UNITED STATES PATENT AND TRADEMARK OFFICE

10/537,443

Office Action Summary	Application No. 10/537,443	Applicant(s) POUTIATINE ET AL.	
	Examiner IAN K. HOLLOWAY	Art Unit 3763

DETAILED ACTION

FIG. 4

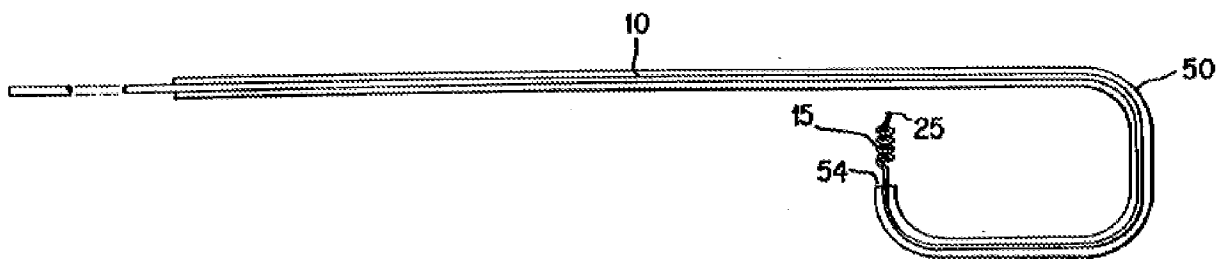
Regarding **Claim 1, Chuttani** discloses a catheter guide apparatus comprising a guide element (Column 6, line 4) configured to fit through a tunneler (Column 6, lines 11-14) and to releasably engage a catheter. (Column 6, line 25-27, the shape and size of the guide element allows for its passage through a tunneler and its ability to releasably engage a catheter)

Regarding **Claim 2, Chuttani** discloses the catheter guide apparatus of claim 1, wherein said guide element further comprises first (25) and second (14) ends, (Abstract lines 2-3) said first end configured to releasably couple to said catheter (15). (Abstract lines 3-4, the coil is able to perform this task)

Regarding **Claim 4, Chuttani** discloses the catheter guide apparatus of claim 1, wherein said guide element further comprises a helix (15) adjacent one end, (Column 6, line 26) said helix including at least two coils, (Column 6 lines 26-27) said spacing between said coils being sufficient to pass said catheter between adjacent ones of said coils.
